| AMENDMENT OF SOLICITATION/MODIFICATION OF CONTRACT   |   |  |                   | 1. CONTRACT ID CODE  |   | PAGE    OF    PAGES                     |                                |  |

1. The specifications and drawings for Invitation No. DACW64-02-B-0021, Dredging, Barbours Cut Terminal Channel in Harris County, Texas, Houston Ship Channel, Texas, advertised 11 April 2002, and for which bids are to be opened on 14 May 2002, are hereby modified as follows:

SKETCH NO. 1

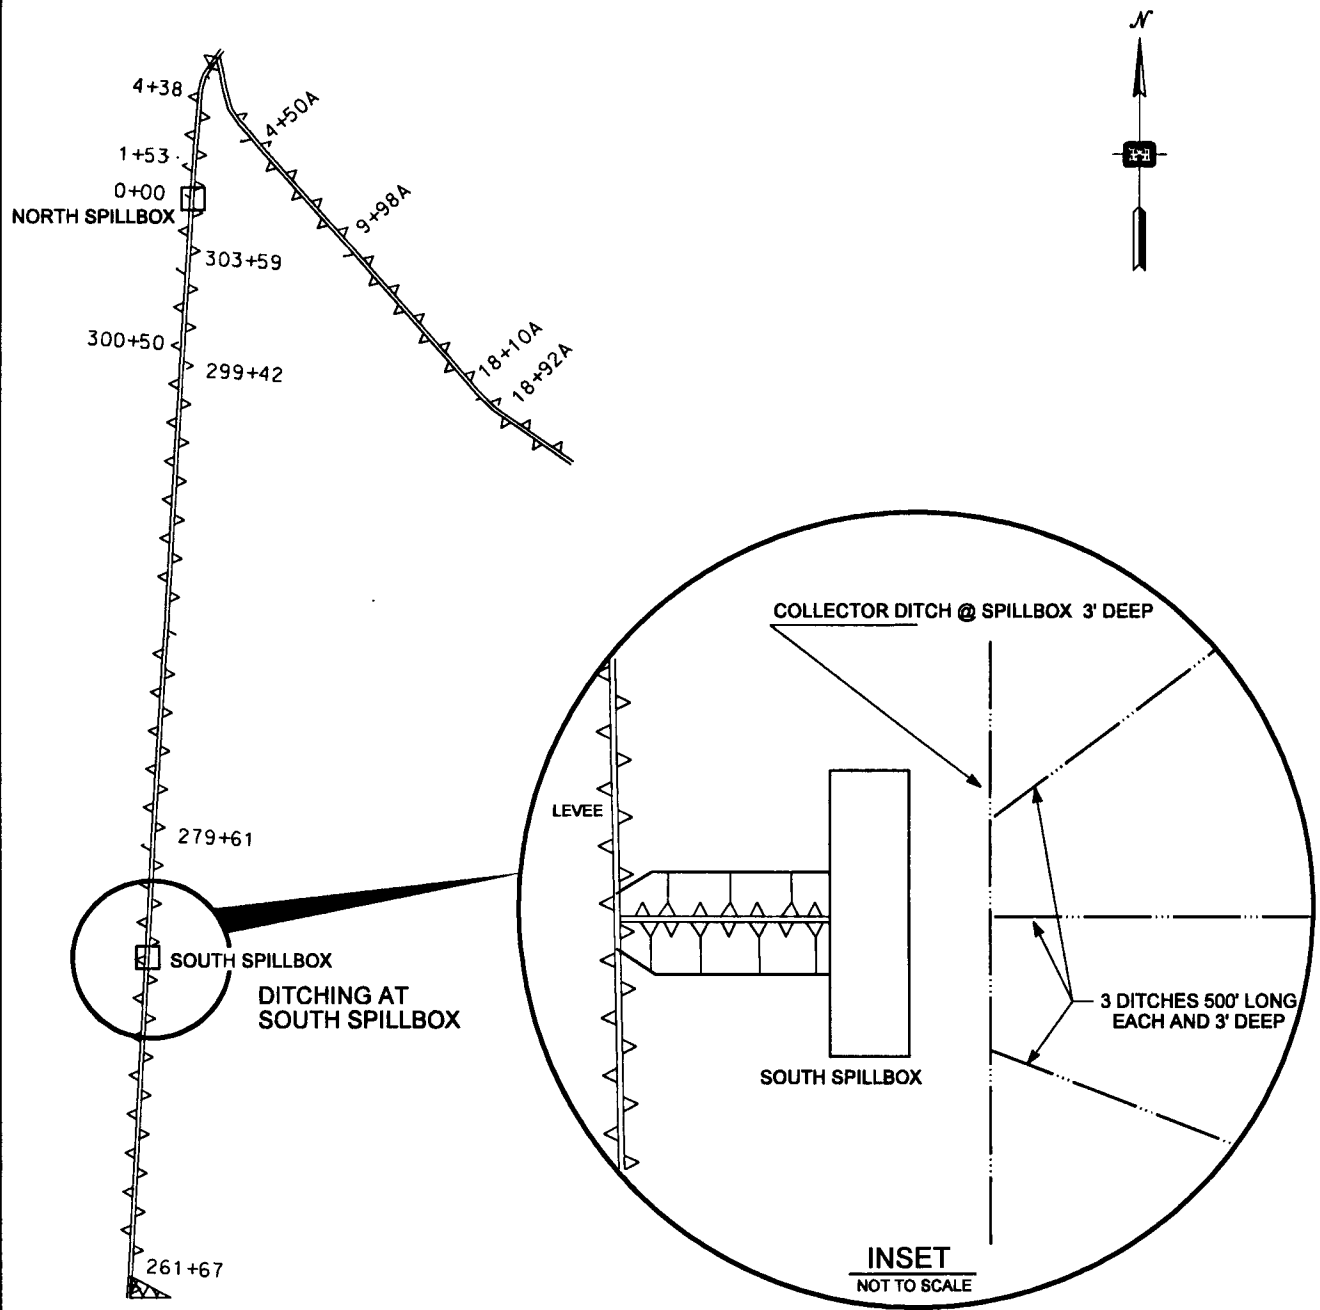
“1.1.3 Ditches. Three (3) ditches shall be excavated to the south spillbox as shown. A fourth ditch shall be excavated adjacent and parallel to the front of this spillbox, connecting with the three (3) ditches specified herein. These ditches shall facilitate draining ponded water through the dredge material that has built up in front of the spillbox.”

- (1) Three (3) ditches 3 feet deep with a 2-foot bottom width shall be excavated for a 500-foot length through dredged material that has built up in front of the south spillbox, as shown.
- (2) One (1) collector ditch 3 feet deep with a 2-foot bottom width shall be excavated adjacent, parallel to, and along the entire front of the south spillbox, connecting the three (3) ditches specified above

(2) SKETCH NO. 1. - The enclosed new SKETCH NO. 1 shall be attached to and become part of the contract drawings to this Invitation.

TO BE ADDED TO SHEET 2 OF 5.
